802.1CB maintenance

"257" – FRER Fixing recovery window

IEEE 802.1 Maintenance TG
March, 2020

- Scene1: no loss, what is in the variables at "T"

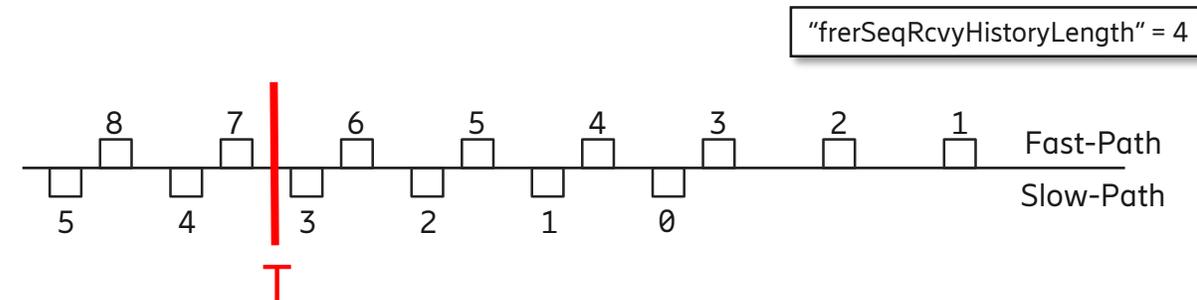
- Slow path packets discarded as already received over fast-path

- RecovSeqNum = 6

- SequenceHistory = [1, 1, 1, 1] referring to "6", "5", "4", "3"

- Last packet "3" discarded as already in history (delta = -3)

- Next packet "7" will be accepted (delta = 1)

— Scene2: fast-path "3-4" lost due to e.g., BER

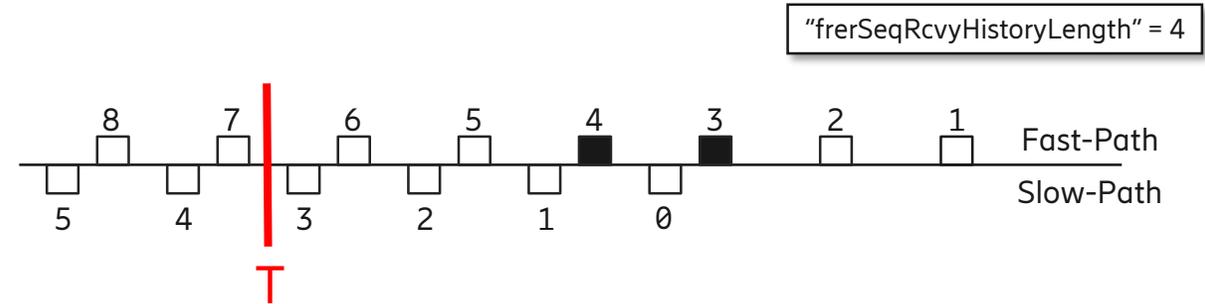
— Slow path packets fill in what
was not received over fast-path

— RecovSeqNum = 6

— SequenceHistory = [1, 1, 0, 1] referring to "6", "5", "4", "3"

— Last packet "3" accepted as not in history (delta = -3)

— Next packet "7" will be accepted (delta = 1)
